*STP-209-1(2) Roadway and BHF-209-1(3) Bridge  
Widening of SR 74 From SR 85 to*

*P.I. Nos. 322355 and 322357*

**Value Engineering Study Report**

Preliminary Design Stage

Reduce length  
of left turn lane

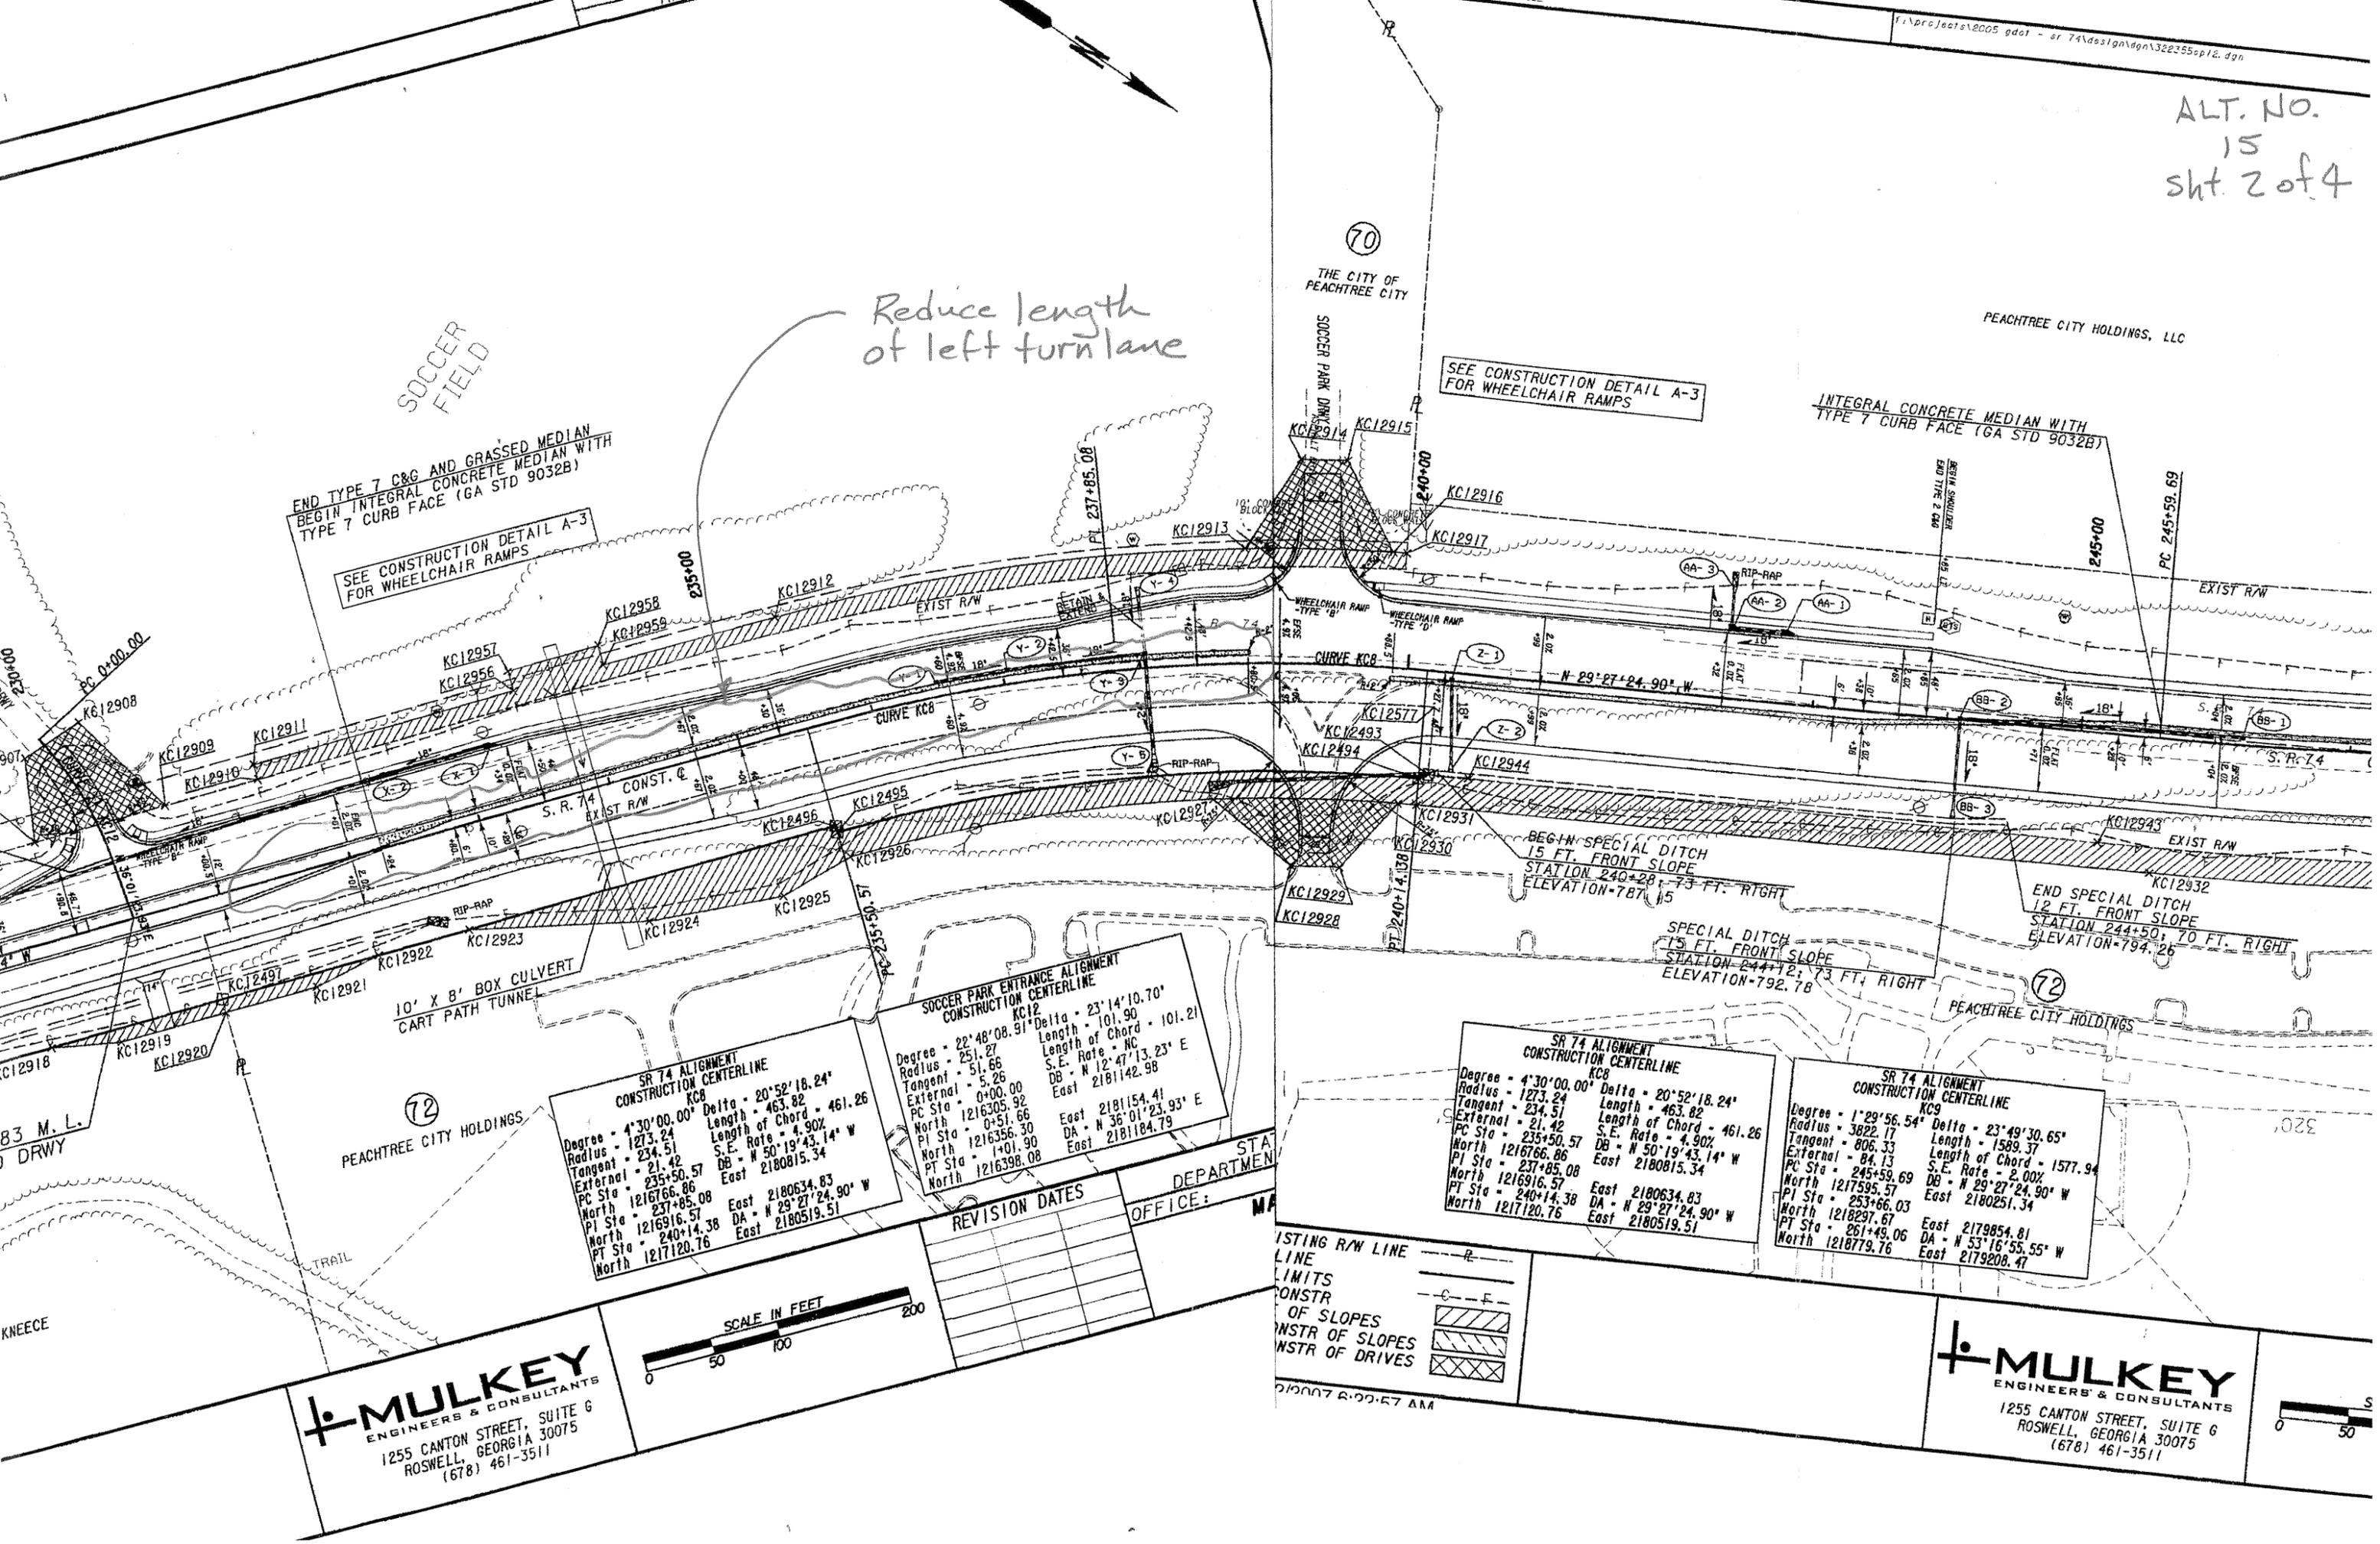
Provide 150 ft. of storage length, enough to hold six cars. This is more than the two-car minimum recommended in the 2004 edition of AASHTO.

DESCRIPTION: **ELIMINATE THE NORTHBOUND U TURN AT STA. 250+00 AND IMPROVE THE SOUTHERN MOST ENTRANCE TO THE BASEBALL FIELD COMPLEX** SHEET NO.: **1 of 5**

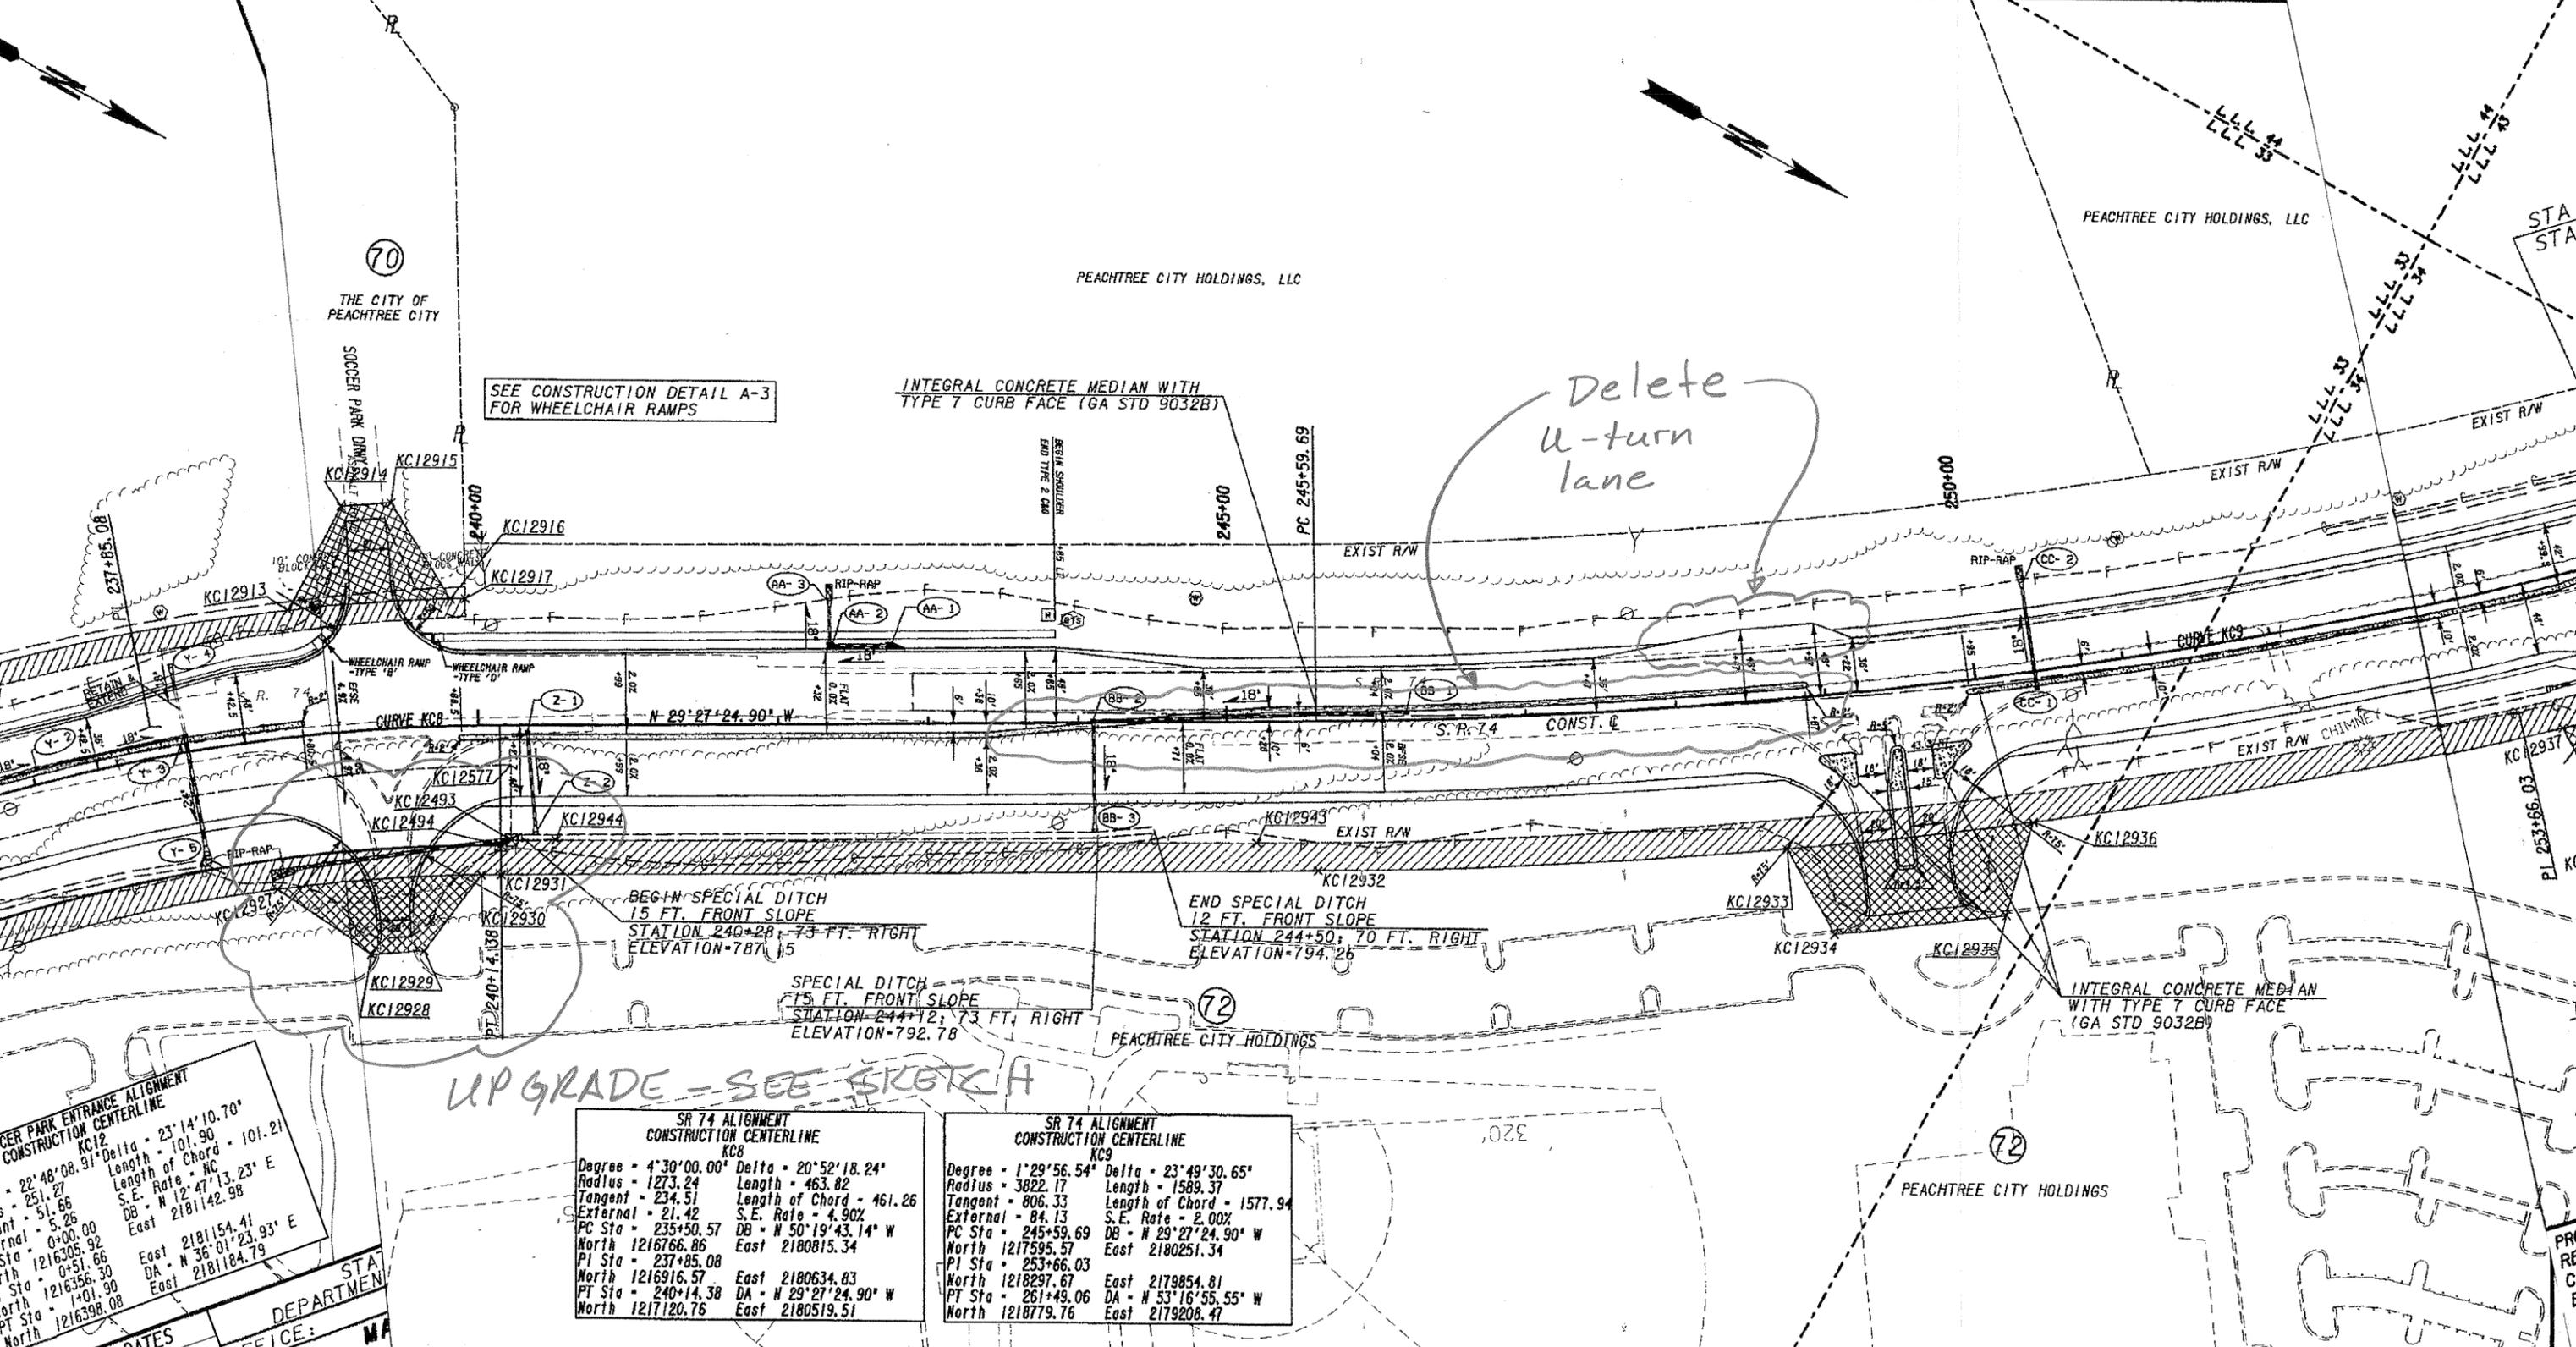
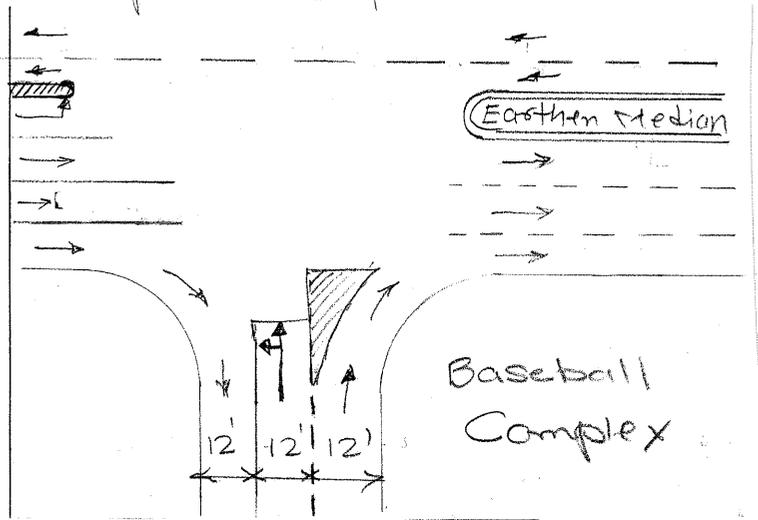
The northbound U turn at Sta. 250+00 will primarily be used by traffic exiting the baseball field complex at Sta. 240+00. Since a left turn can be made to SR 74 southbound from the baseball field complex, the U turn is redundant. The exit from the baseball complex at Sta. 240+00 should be widened from the original design to separate left and right turning traffic.

Since a left turn lane to the baseball field complex is already proposed 1,000 ft. away (at Sta. 250+00), this left turn lane can be eliminated. A triangular striped island should be provided. The entrance width should be increased to 36 ft., providing a left turn lane onto SR 74.
